22023-L07-SW

PALL MALL COURT – PLANT NOISE EMISSIONS

Figure 1: Screenshot from Noise Model, 2D

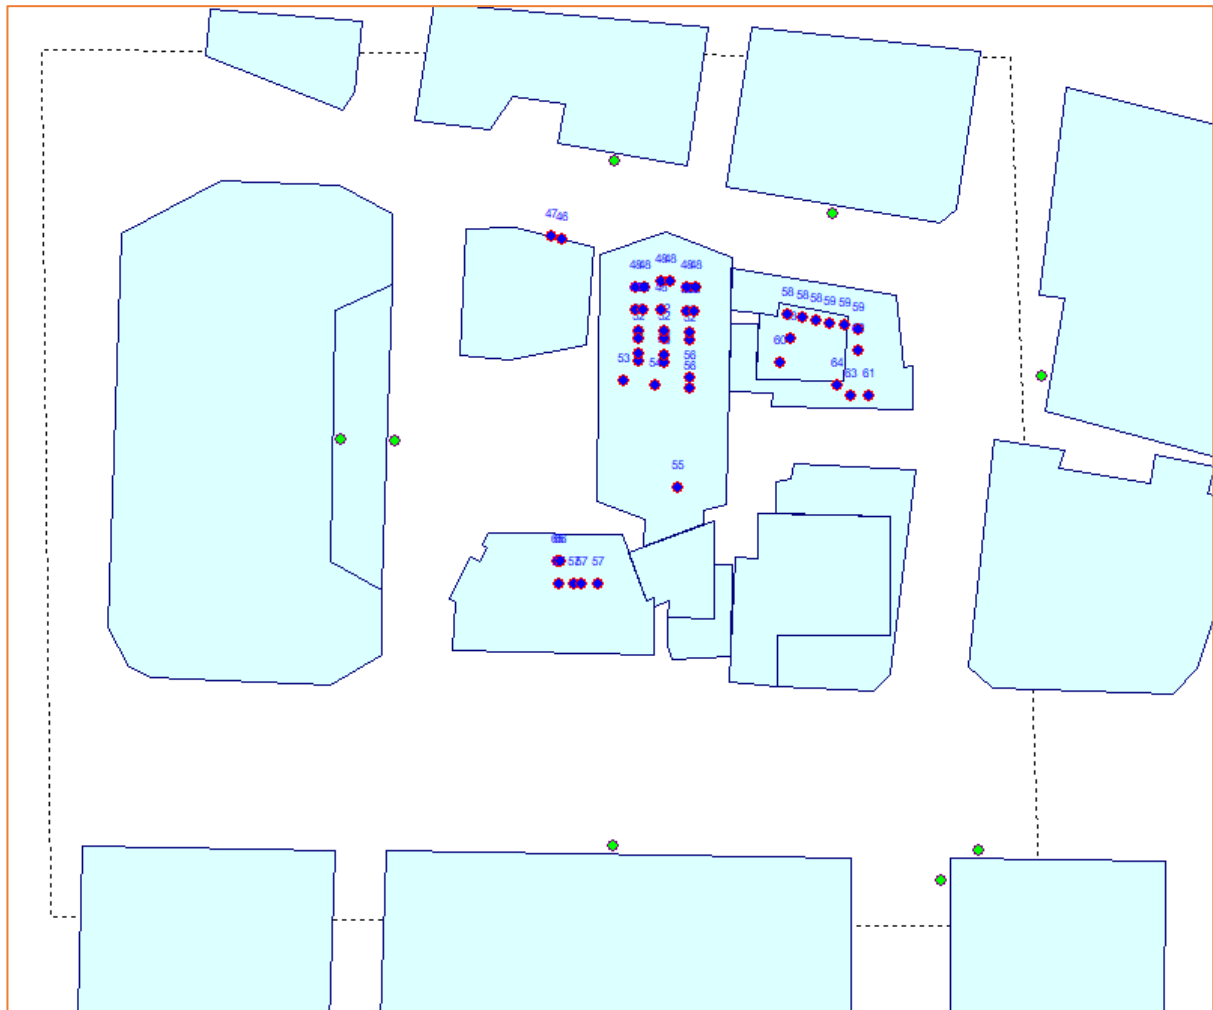
Thank you for forwarding the queries received from Manchester City Council relating to plant noise emissions at Pall Mall Court.

Nonetheless, this letter presents information on the modelling process and results to allay the concerns raised by MCC.

Screenshots from the model are shown as Figures 1 and 2, below. The model includes the reselected AHU-RF-01.

The results of the plant noise emission model indicate that the building services noise emission limits will be met for the receptors at King St (including Hotel Gotham) and Marsden Street, but will be slightly exceeded at 30 Brown Street, where a building services noise level of up to $50dBL_{Ar,Tr}$ is predicted for the upper floors. This does not exceed the existing background noise level at this receptor which, given the context of a noise climate already affected by building services noise, would indicate that an adverse noise impact is unlikely.

As described above, no further mitigation of plant noise is practically achievable.
